CUSTOMER NOTIFICATION

Title VolumePro 1000 with 512 MB Jumper Configuration.

Date	CN No.	Contact	Contact Information
16 September 2002	09160201	Frank Uyleman	Email: uyleman@terarecon.com Toll-free telephone (USA only): (800) 746.1849 Telephone (domestic and international): (617) 424.9405 Fax: (978) 369.7724

Product	Part Number	Description
VolumePro 1000	02-0020	VolumePro 1000 board with 512 MB memory

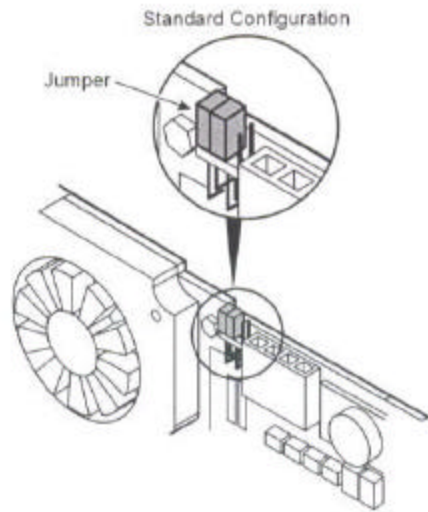
We have recently discovered a possible issue with shipped VolumePro 1000 with 512 MB boards. Boards may have been shipped from the factory with an incorrect JP1 jumper setting. The correct number of jumpers and jumper installation locations are shown below. The jumper can be found on the front top edge of the board between the fans and one of the power input plugs. These jumpers are provided to allow flexibility in system configuration. The standard two jumper installation shown is best for most applications.

Missing jumpers or jumpers installed at incorrect locations may cause unstable system behavior such as:

- Board/driver not starting
- Board works fine, then suddenly does not response after re-boot
- System does not boot

Please inspect your board to verify it has the correct jumper setting.

If the board jumper settings are wrong, please correct per the above diagram.

If the board is missing jumpers you can:

- install needed jumper if you have it
- contact us and we will ship you any you may need. Please provide an appropriate address for us to immediately send the jumpers to. Please send your request to the above contact person.
